ADDENDUM #3

THE WICHITA AIRPORT AUTHORITY
 COLONEL JAMES JABARA AIRPORT

FENCE DETAILS

SANITARY SEWER AND WATER DISTRIBUTION SYSTEM
 SOUTHWEST AREA SITE DEVELOPMENT IMPROVEMENTS

Painted Slump Block Column
 (1.5'x1.5' w/Cast Stone Cap)
 Paint Color to be Selected by Owner

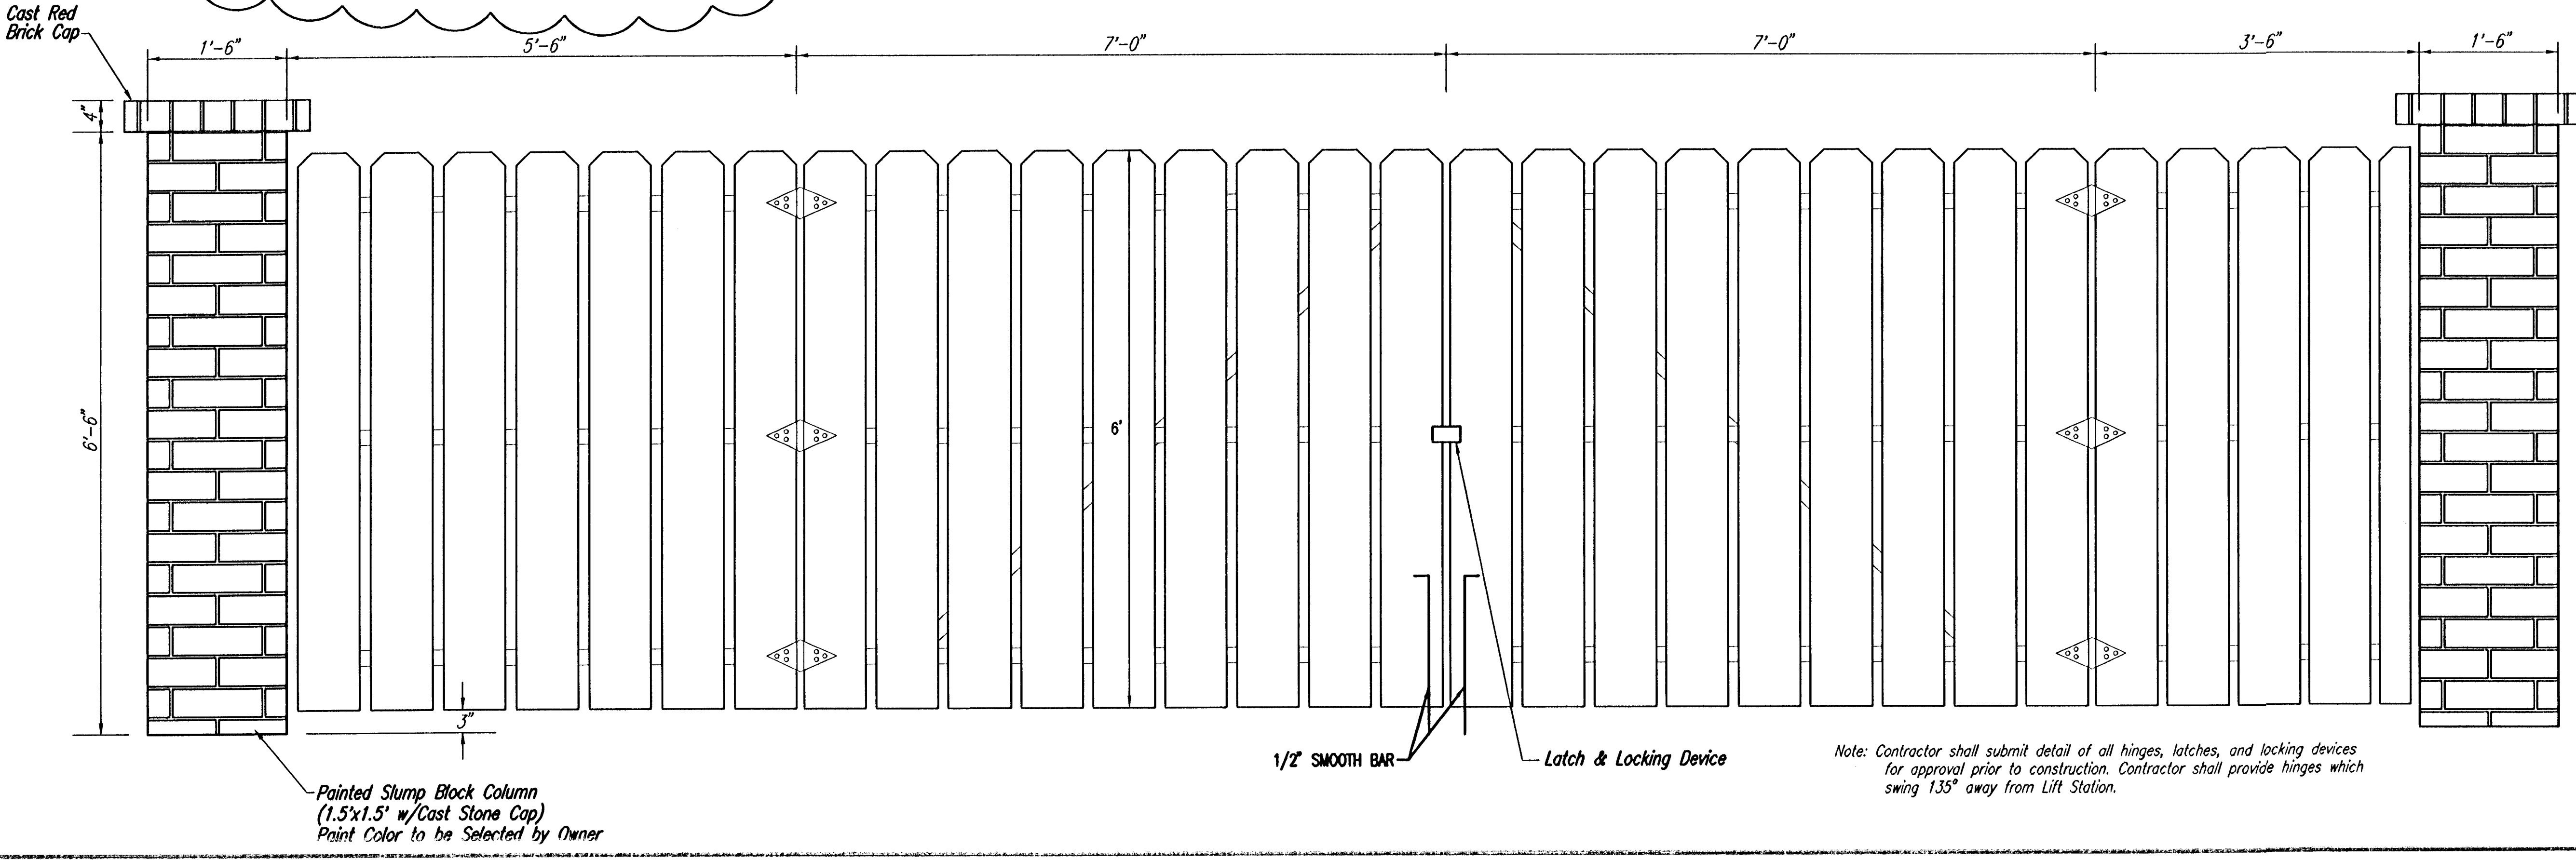
- ADD. #3**
ITEM NO. 6 SHEET CF1.1 - FENCE DETAILS
- A. DELETE CONCRETE MOW STRIP DETAIL. CONCRETE MOW STRIP WILL NOT BE REQUIRED ON TEMPORARY FENCE. SEE CHAIN LINK FENCE DETAIL FOR CONCRETE FOOTING ON PERMANENT FENCE.
 - B. CHAIN LINK FENCE DETAILS, ADD THE FOLLOWING NOTE: "TWO (2) NO 5 BARS SHALL BE INSTALLED IN THE CONCRETE FOOTING. THE REBAR SHALL BE SPACED 1'-0" APART AND SHALL BE PLACED ON EITHER SIDE OF THE POSTS".
